William States Lee III Nuclear Station

COL Application

Technical Specifications

Revision 2

Figure 4.1-1

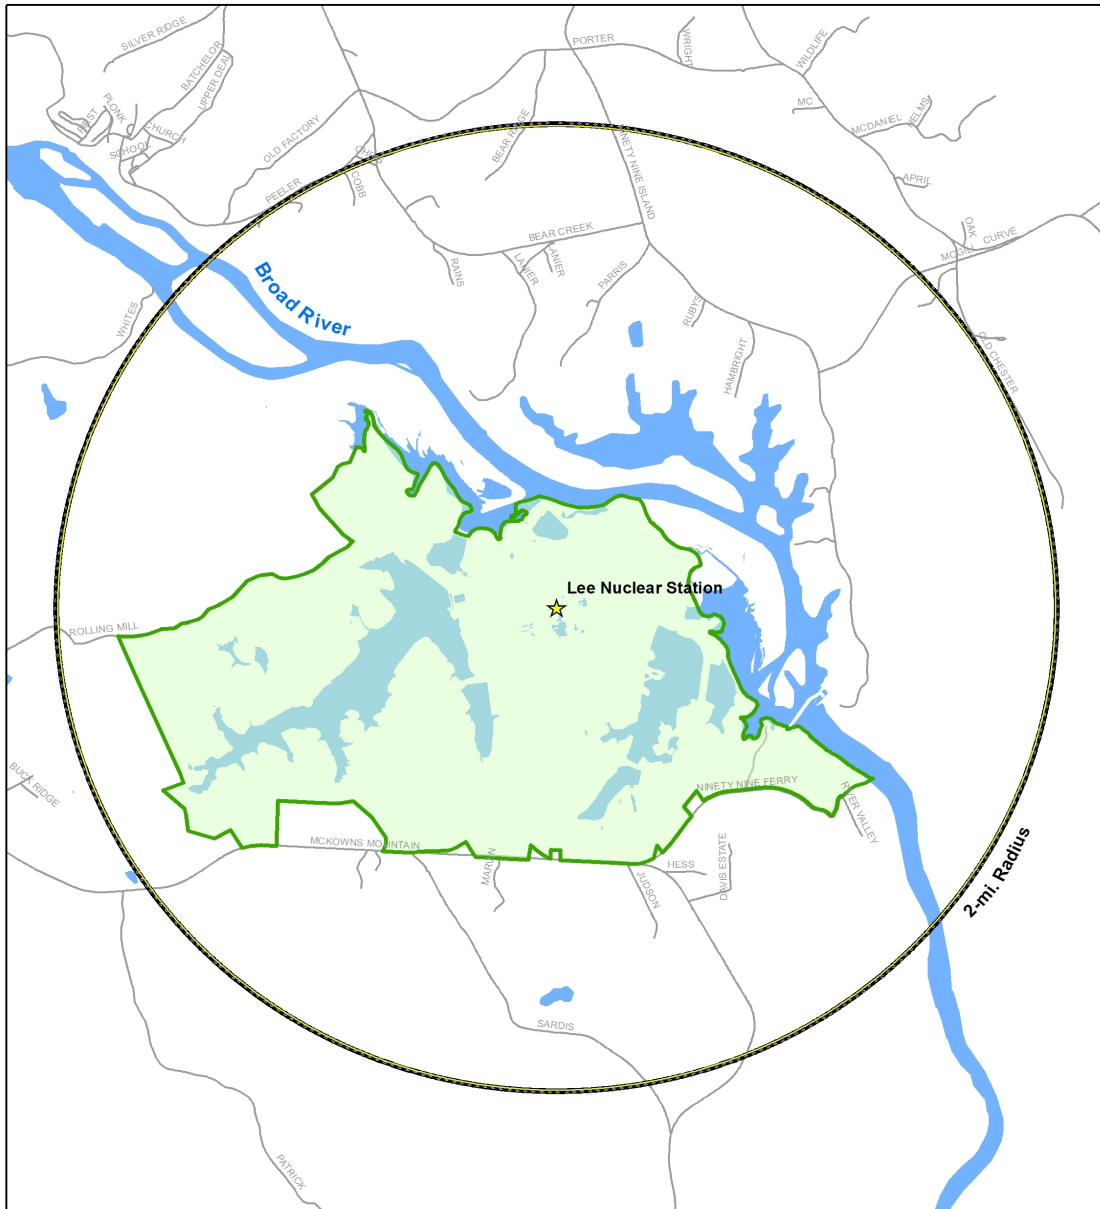
- GTS 4.1.1 The bracketed information in the GTS reads:
[This information will be provided by the combined license applicant.]
Replace the bracketed information in the GTS with the following:
The Site Boundary is shown in Figure 4.1-1. The Exclusion Area Boundary is shown in Figure 4.1-2.
Justification:
Bracketed information is replaced to establish Site Boundary and Exclusion Area Boundary for Lee Nuclear Station consistent with the descriptions identified in FSAR Sections 2.1.1.2.

- GTS 4.1.2 The bracketed information in the GTS reads:
[This information will be provided by the combined license applicant.]
Replace the bracketed information in the GTS with the following:
The LPZ is defined by the 2 mile radius from the site center point as shown in Figure 4.1-1.
Justification:
Bracketed information is replaced to establish the LPZ for Lee Nuclear Station consistent with the descriptions identified in FSAR Section 2.1.3.4.

The Site Boundary is shown in Figure 4.1-1.

The LPZ is defined by the 2 mile radius from the site center point as shown in Figure 4.1-1.
